APPLICATION NO: 03/2021/0656/PF

PROPOSAL: Creation of off road domestic parking, formation of access, landscaping and associated works

LOCATION: Land to the rear of 20 Regent Street, Llangollen

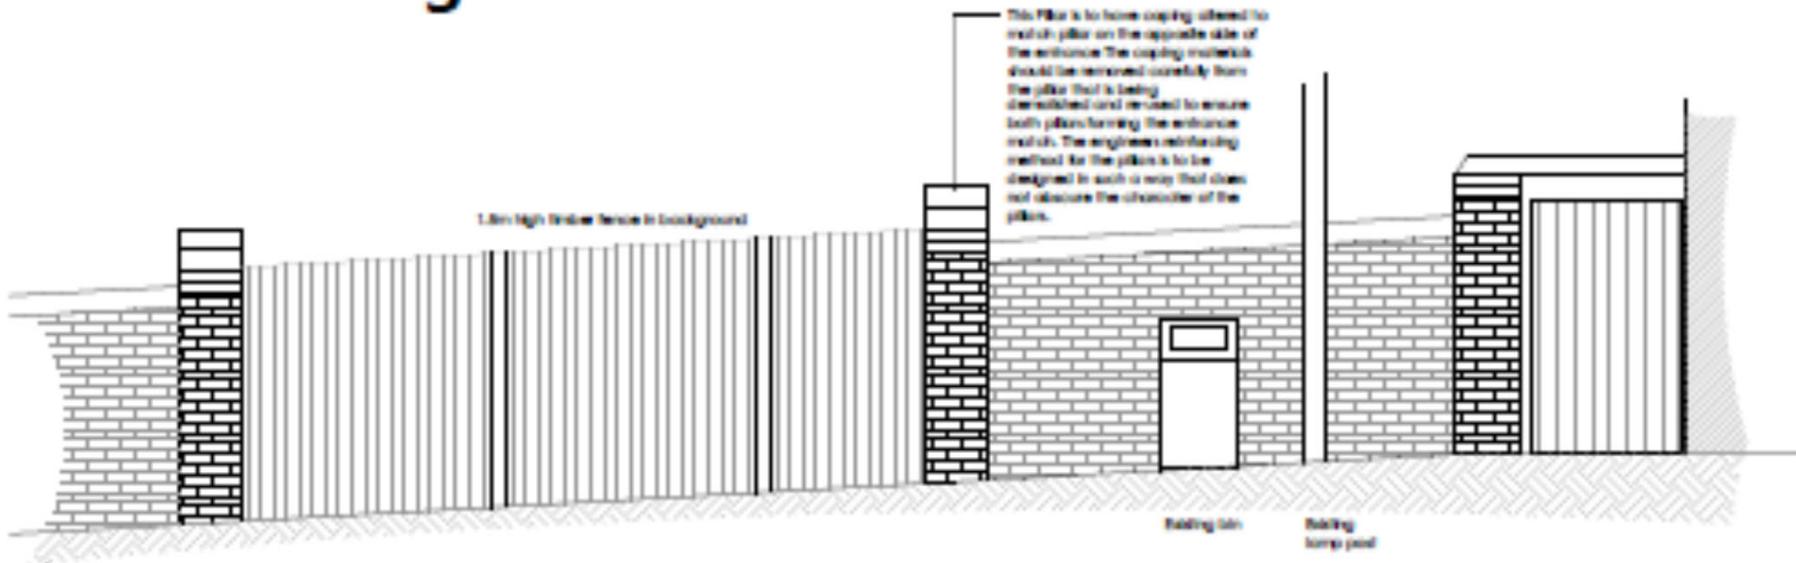
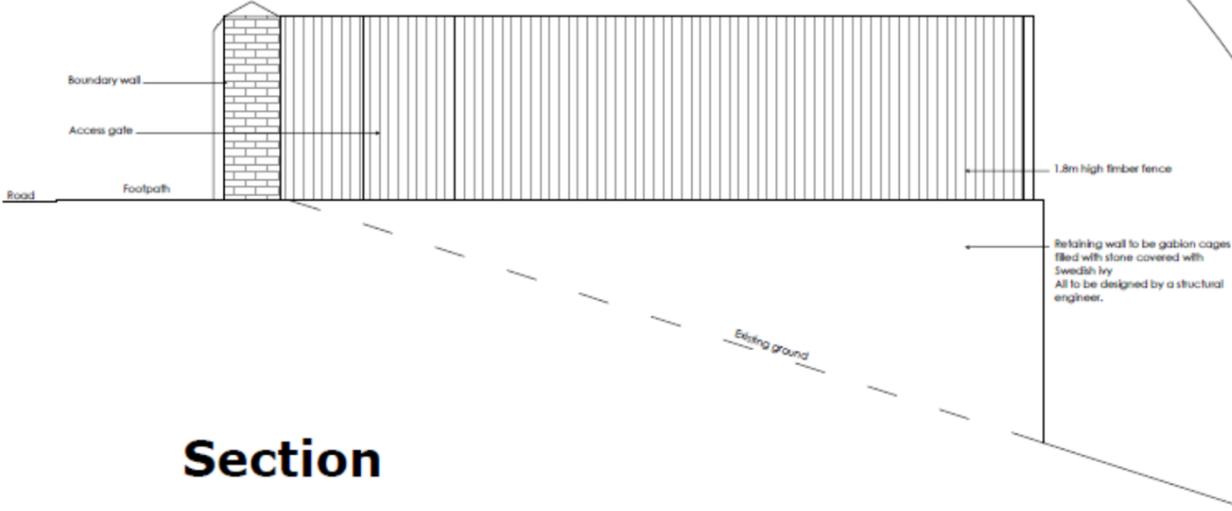
- To reduce the negative visual impact of the loss of boundary wall within the Conservation Area please reduce the opening size of the access and I would suggest leaving the lower pillar as shown and having the opening width to the pillar just below the existing bin which will still allow easy access for cars. This will also provide an opening with a pillar on each side which will be more balanced in appearance. The pillar just below the bin will need to be altered to match the same detail as the lower pillar so that they match exactly with the same coping details etc.

'Following my previous comments I can confirm all is now acceptable apart from the right hand side pillar at the entrance which has not been shown to match the left hand side pillar as requested. Please note the coping materials should be removed carefully from the pillar that is being demolished and re-used to ensure both pillars forming the entrance match.

- 1.1.4 The pillar on the right side of the proposed access pillar is to have copings altered to match pillar on the left side of the proposed access. The coping materials would be removed carefully from the pillar that is being demolished and re-used to ensure both pillars match. The engineers reinforcing method for the pillars is to be designed in such a way that does not obscure the character of the pillars.

The proposed plans were amended to reduce the amount of wall to be removed to reduce any negative visual impact of the loss of boundary wall within the Conservation Area. They also detail that they would use the existing pillars to be used as the boundary for the access and materials from the pillar that will be removed (from the side of the gate).

Section

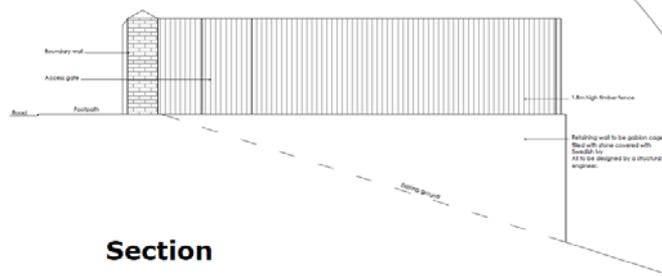
It is also noted on the drawings that the existing front boundary walls and pillars are to be reinforced to the Engineers details, please clarify what this will involve and if it will have any visual impact on the walls from the road'.

A representation was also querying the levels of the proposed site. These are detailed to follow the land with a fall from west to east. The retaining walls would follow this incline. It is considered that this can be achieved and is noted that this would be designed by an engineer.

- 1.1.5 The proposed parking area is detailed to follow the fall of Hill Street and be built up to be at the same level as Hill street above the slope the land (which falls down northward towards 20 Regent Street). The retaining structure would consist of gabions filled with stone. This is also noted to be covered in Swedish Ivy. Above this there would be a 1.8 timber fence which is noted to be close boarded timber to be natural timber colour. This is just below the height of the brick wall that bounds Hill Street. A timber access gate and steps are proposed to provide access to the western side of the proposed parking area into the garden of 18 Regent Street, which the proposed parking area is to serve. A tree is required to be removed from here to facilitate the development.
